MINOR VARIANCE REPORT

APPLICATION: A/082/2025

A/082/2025 - 59 Cudmore Road (West District) (OP Designation: Low Density Residential)

Figure 3: Ground floor plan excerpt

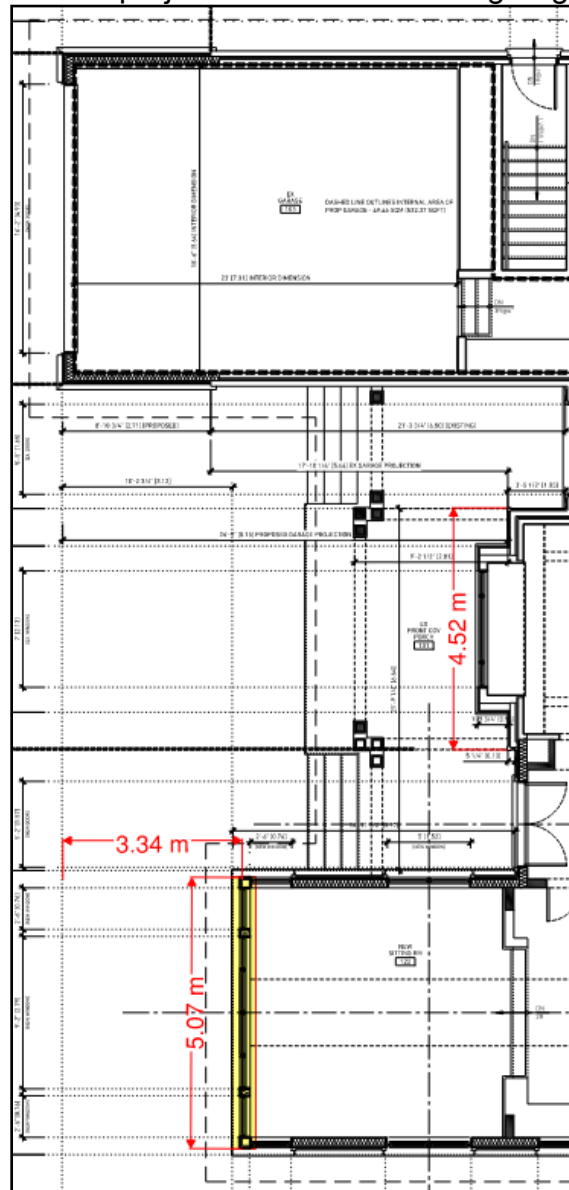
With respect to variance #5, the attached garage projection is to be measured from the main wall of the principal dwelling. The main wall of the dwelling is proposed to be established as the new sitting room located on the south side of the dwelling, resulting in a reduced attached garage projection variance of 3.34 m. Figure 3 below shows the dimensioned main wall and projection of the attached garage from the main wall.

Should variances number 1, 4, 6, and 7 be approved, variance number 5 be approved as modified to reflect an attached garage projection of 3.34 m, and variances 2 and 3 denied, the following conditions are recommended:
